From: Danny Yee <danny@oxlivsts.org.uk>
Sent: 01 November 2023 10:05
To: Planning
Cc: Catherine Hickman; White, Joy - Oxfordshire County Council; JacquiCox (OCC); damian.haywood@oxfordshire.gov.uk; Thomas Webster; Councillor Daniel Sames; calum.miller; Cllr Andrew Gant; Robin Tucker; Paul Troop; Eden, Oliver - Oxfordshire County Council; Zuhura Plummer
Subject: Re: 23/01080/OUT and 23/02399/REM (NEW)

Oxfordshire Liveable Streets objects to this design too.

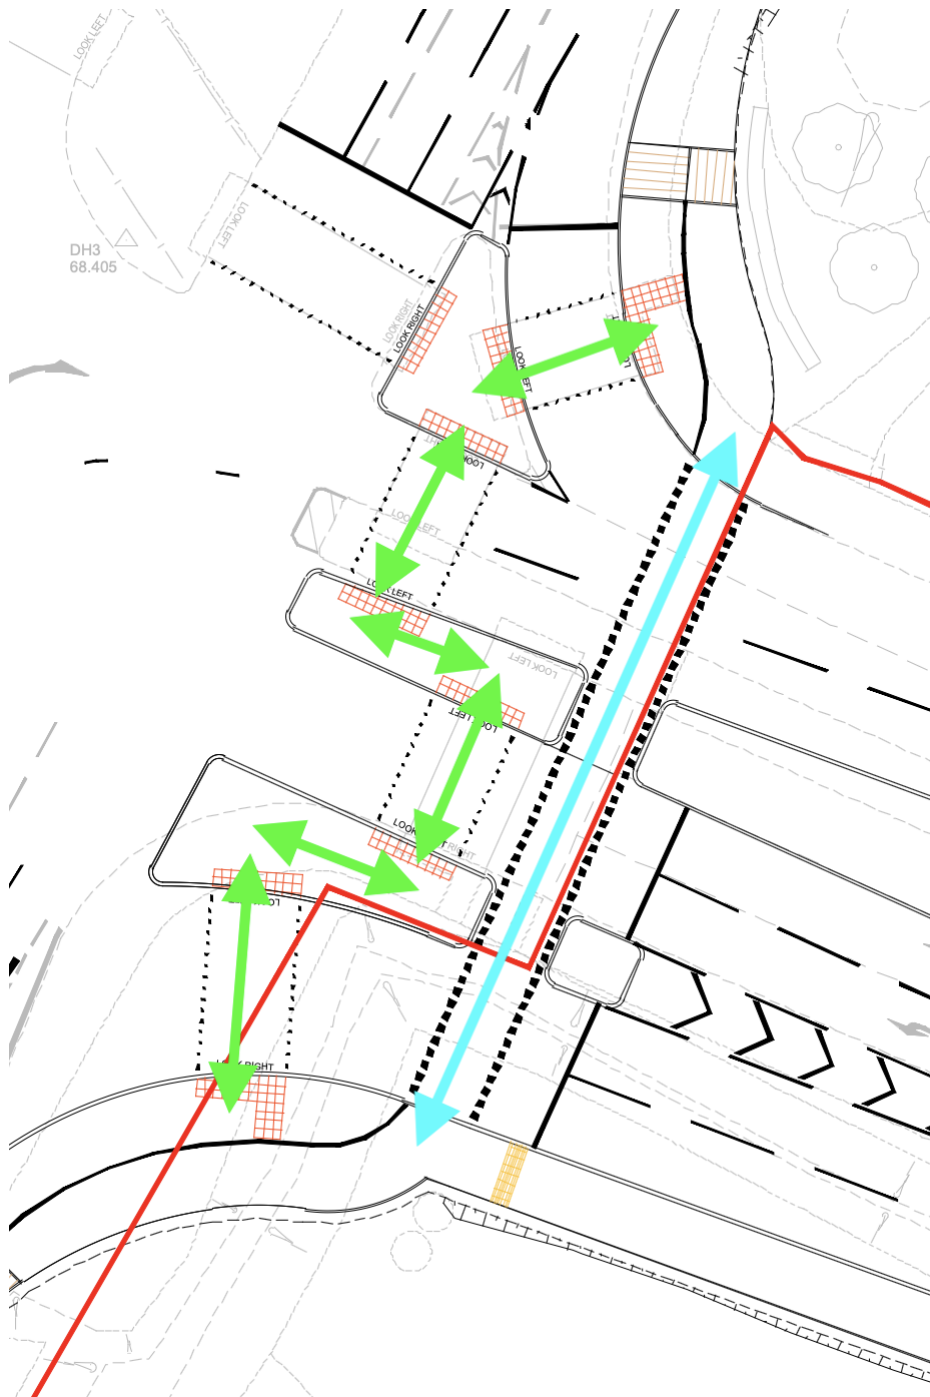
Requiring four staggered stages for someone walking to make a single crossing of the development entry is positively anti-pedestrian and needs to be rethought completely. We suggest aligning the pedestrian crossing with the cycle crossing (and possibly on the inside rather than the outside of it). That will avoid confusion for drivers who will not expect to have to stop twice in quick succession for crossings. It would also allow the crossing to be reduced to two pedestrian stages.

And cycling must be buffered from motor traffic with 40mph speeds. Table 6-2 in "Cycle Infrastructure Design" (LTN 1/20) requires 0.5 metres at "an absolute minimum" - and recommends 1 metre.

The design is a modest improvement over the initial concept in that the pedestrian and cycle crossings have been decoupled. However:

1. The frontage of the site is a 40mph road. LTN1/20 requires a buffer of at least 0.5m, and advises at least 1m. At present the applicant is proposing zero buffer.

2. The Bicester LCWIP specifies that both frontages (A41/Oxford Road & Lakeview Drive) should be segregated paths. The OCC CDS also require segregated paths alongside spine roads such as the A41. At present the applicant is proposing shared.

3. Though we do not have a mandate for pedestrian provision, the pedestrian crossings are truly awful and will effectively prevent anybody from walking along the A41. There are 4 separate crossings, no doubt with long waits at each crossing, each are staggered in a way that is unlikely to comply with the Equality Act as they will be almost impossible to navigate in a wheelchair, and the islands are way too narrow. Surely we could do better here, even if it was to reduce the angle offset to below 90°? Ideally the number of pedestrian crossings would also be reduced to 2 or at least 3 - with bigger islands.

4. The standard arrangement of a junction is always to have the cyclists closer to the motor vehicle traffic and the pedestrians further away. This design reverses this logic and will inevitably cause conflict between pedestrians and cyclists. A better arrangement must be possible.
